**Upcoming Regulation 128 Changes related to  
LED Light Sources for Forward Lighting Applications**

In support of document GRE/2016/34

Main Drawing, L1A

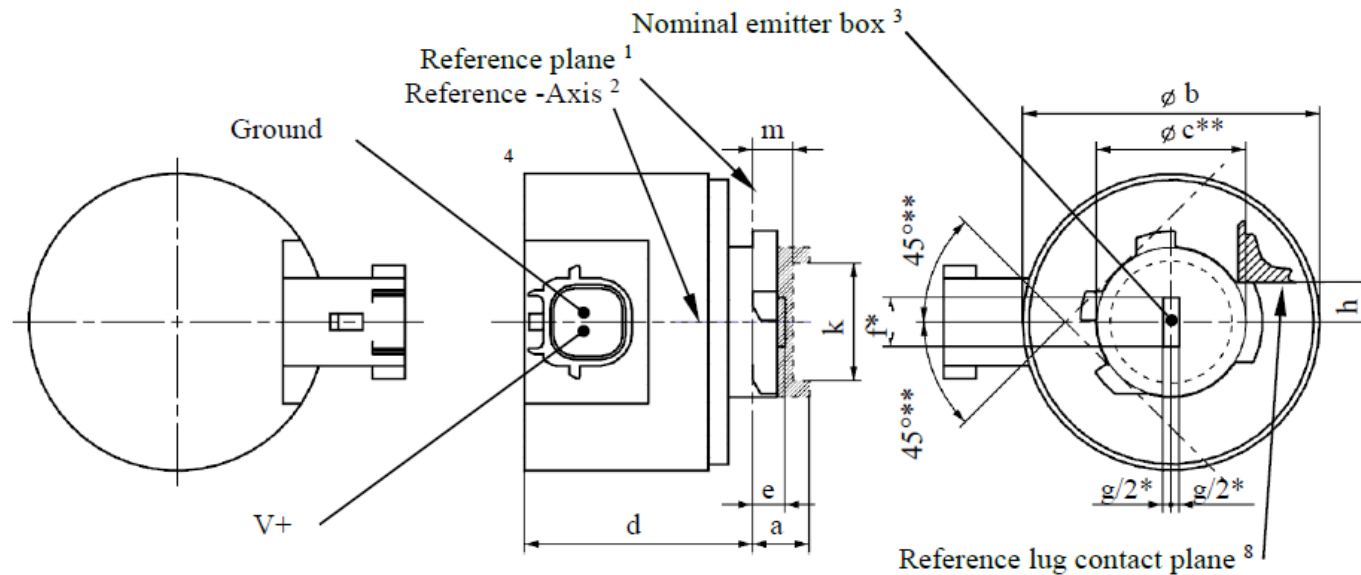
# Amendment to Resolution Category L1 Sheet

For inclusion in Resolution [R.E.5]

➤ L1A shown:

L1  
Light Source

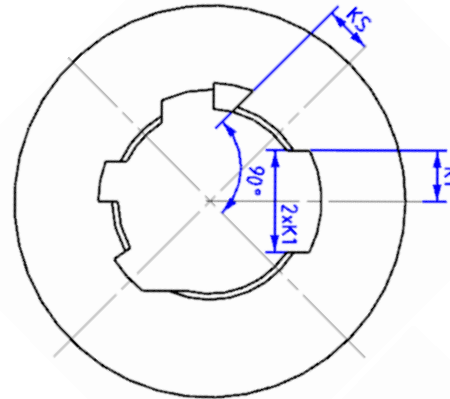
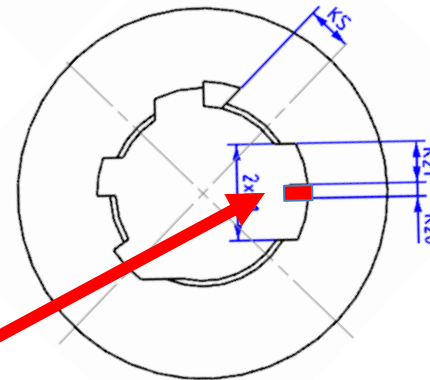
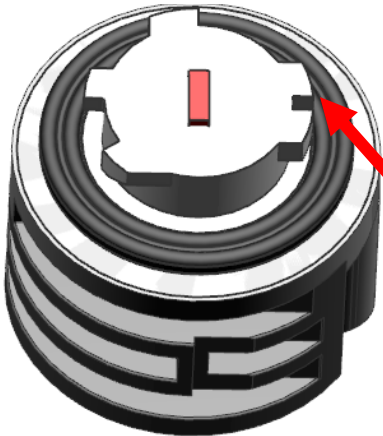
Interchangeability is guaranteed through established IEC Cap/Holder specification process, assigning unique keys to each Thermal Grade
